Ref. ITB-2021-PAL-145607  
 UNDP e-Tendering event ID: PAL10-9573  
 Addendum 01 to the ITB

### Addendum No.1 to the ITB

Invitation to Bid (ITB): Establish and Refurbish of:	
Lot 1: A specialized court in Nablus Court building for the benefit of cases of Violence Against Women	
Lot 2: One Stop Centre in Nablus Police Station	
ITB issue Date	23 June 2021
	As set in the relevant e-tendering event
Deadline for submission of bids	PAL10-0000009573 <b>15 July 2021 at 11:00 AM EDT (6:00 P.M. Jerusalem time)</b>

NABLUS ONE STOP CENTER

**Elevator Steel Sheet Cover Typical Detail**

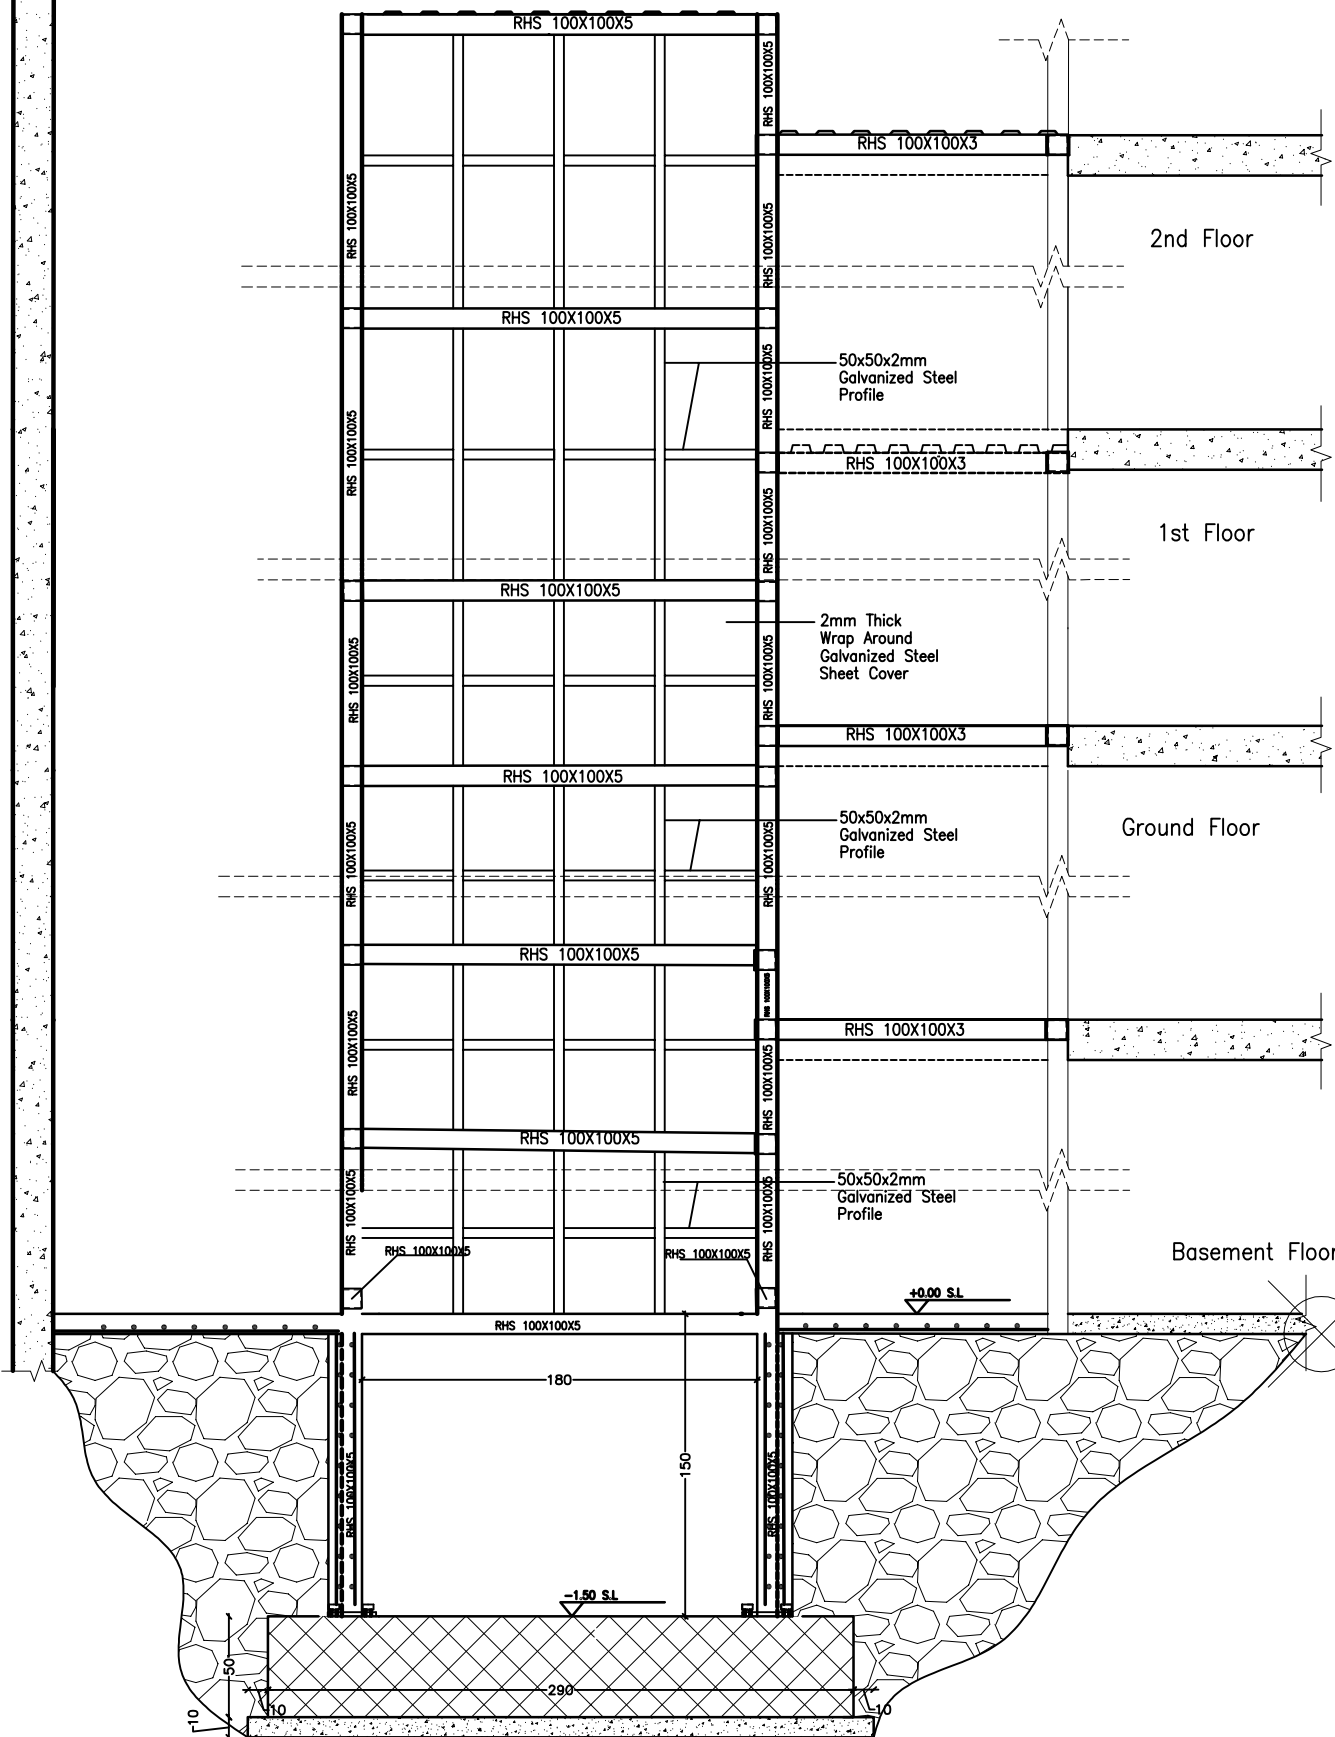
No	Note	Clarification
5	Elevator pit location vs risk of ground water	The side of the steel structure should be covered by steel sheets or fire rated gypsum boards; the designer has provided a modified drawing for the elevator walls attached with this addendum. Regarding the ground water, the contractor before starting the excavation, should conduct a test pit to make sure excavation is possible or not. If not, the levels and the footing design will be modified accordingly.
6	Check on Civil defense requirements for elevator if fully considered in design	The designer contacted the Civil Defense authority and provided us with a detail drawing for the elevator, attached with this addendum. The contractor has to consider all the requirements of the Palestinian Civil Defense in pricing the item of the elevator.
7	Crushed Ytong layer thickness under tiles,	As mentioned in the item, the backfilling under the tiles is composed, among others, of 5cm small size aggregate and the remaining is crushed Ytong. The total thickness depends on the slope needed for sewage pipes.

<b>For Lot 2</b>		
<b>No</b>	<b>Query(s) Raised</b>	<b>Reply/Clarification</b>
3	Item 3.01: Elevator Shaft according to Civil Defense (As In past Projects Experience), will need closing all around and to be flush from inside, Will be there a new item for closing?	Details for closure of elevator shaft are attached, where closure galvanized metal sheet in section shown to be flush from inside the shaft. The price should be included in item 3.01.
4	Item 3.01: Also the Height of floors is not existing in the Section (Drawing S01), Can you please provide us with the vertical dimensions?	Each floor clear height average 3.84 meters.
5	Item 5.01: Is this Item for Demolished wall intersection with external walls and wherever, what about the variance in the levels of plaster after demolishing?	Item no. 5.01 is a plastering of new block walls, while item 5.02 is plaster repairs. As mentioned in the item, this item should be implemented by professional experienced plasterer. Plaster removal is required as needed to make space for both plastering lathe as well as ensure smoothing level variance if exists.

Typical Galvanized Steel Sheet Cover on All Sides of Elevator Shaft.

Cover Sheet to include 50x50x2mm Galvanized Steel Profile, as Shown to secure Cover Steel Sheets

50x50x2mm Profile to be welded to Elevator Steel Structure.

Sheet metal screws to be used for additionally secure sheets to metal grid
